UNITED STATES PATENT AND TRADEMARK OFFICE

APPLICATION NO.	FILING DATE	FIRST NAMED INVENTOR	ATTORNEY DOCKET NO.	CONFIRMATION NO.
10/630,342	07/30/2003	Alan R. Pfaff JR.	11009-22	9300

Office Action Summary

DETAILED ACTION

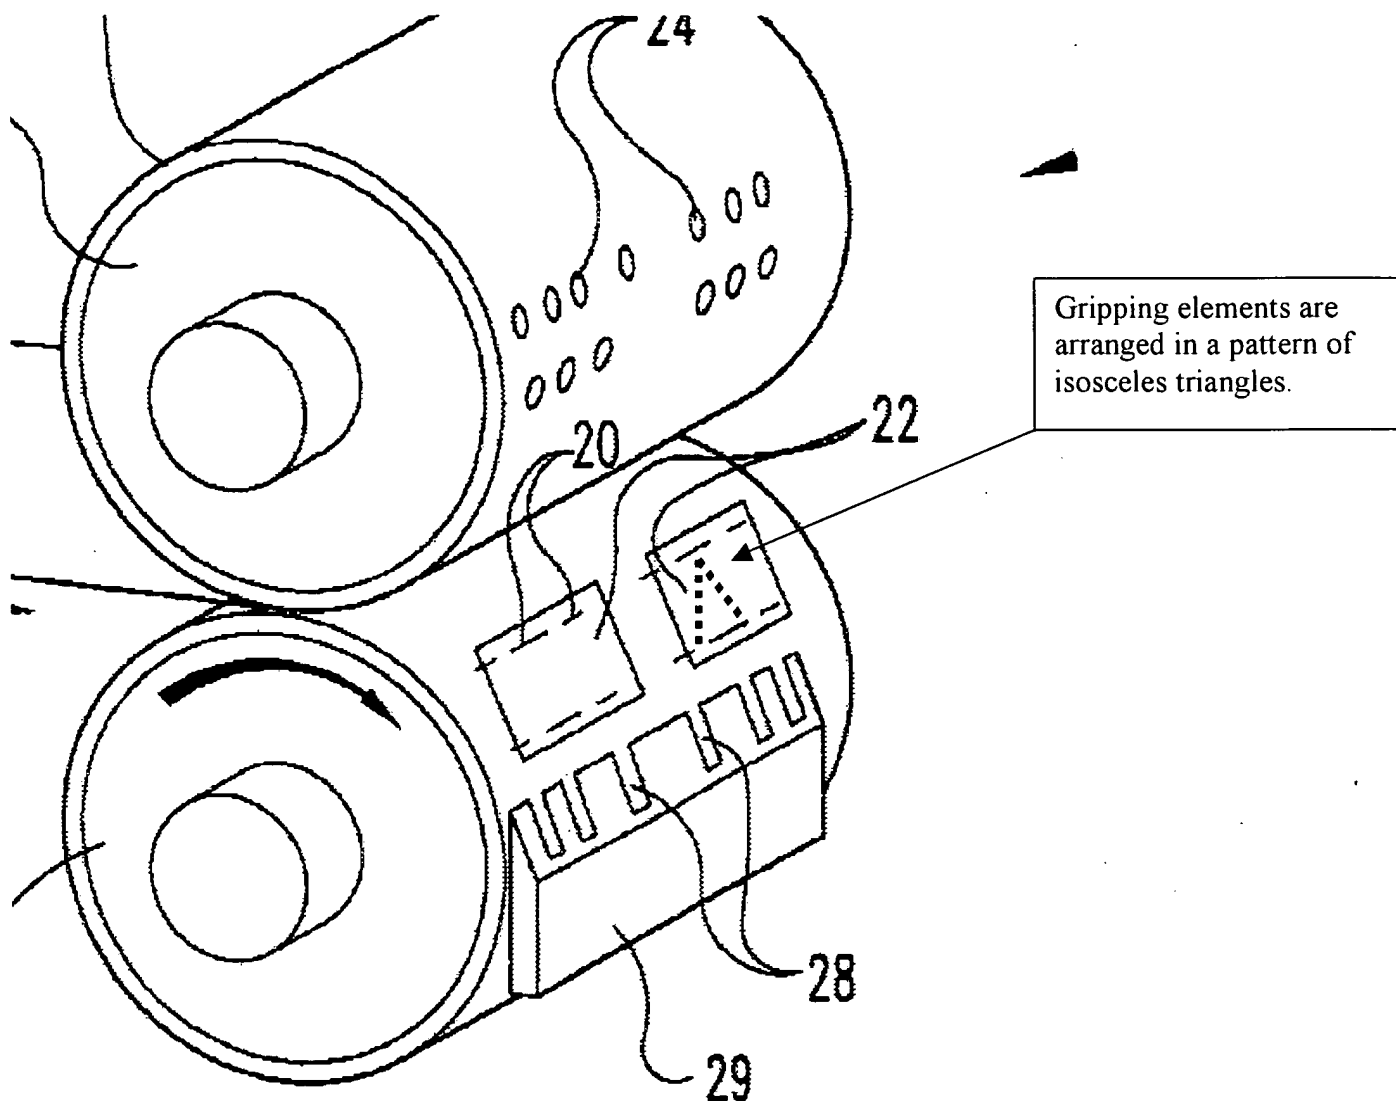
Regarding claim 38, the gripping elements are arranged in a pattern of isosceles triangles. See attached Fig. 1.

Elements 200 are at 3 points of an isosceles triangle

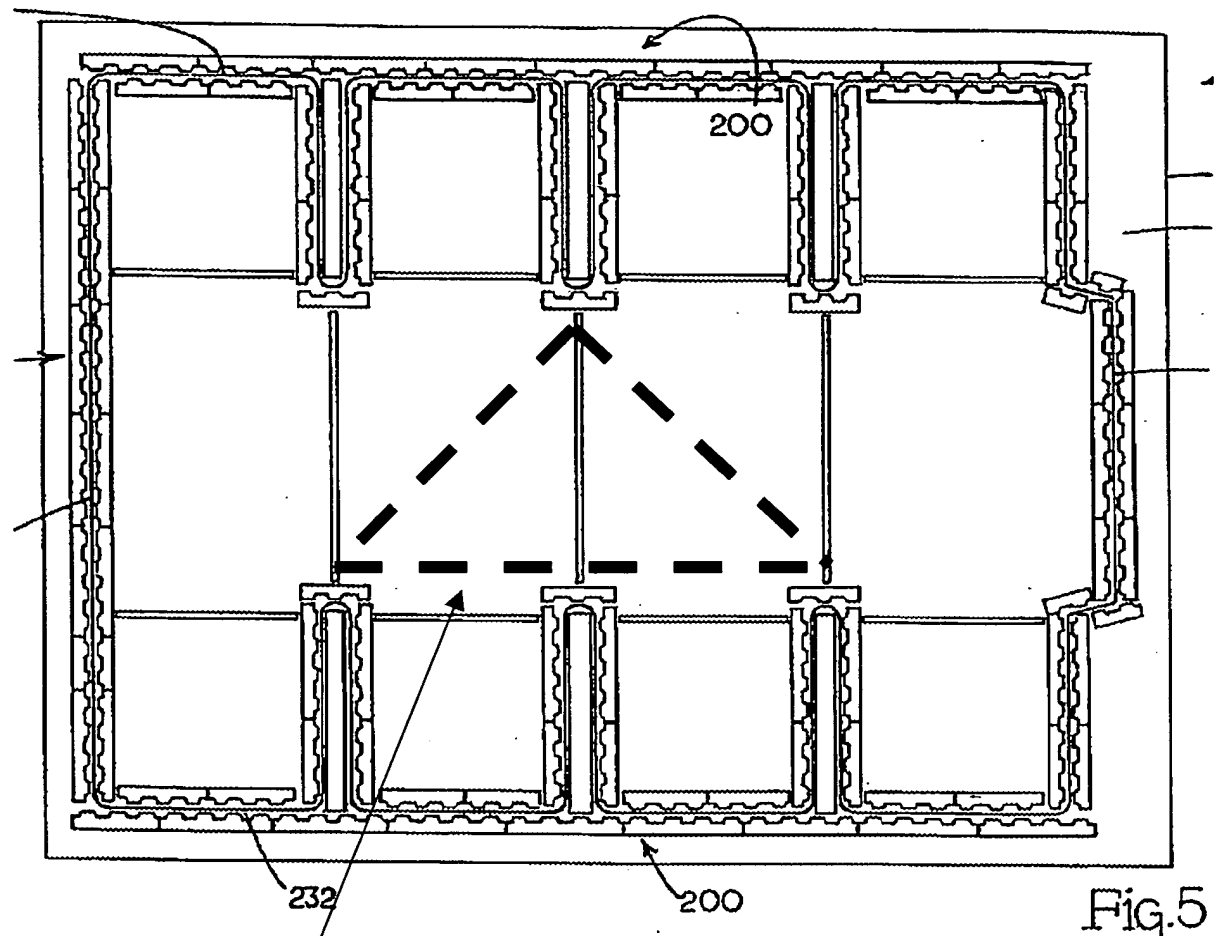
Regarding claims 31 and 32, Applicant asserts that Smithwick does not teach element 200 are at 3 points of an isosceles triangle. Applicant is directed to the attached Fig. 5 below.
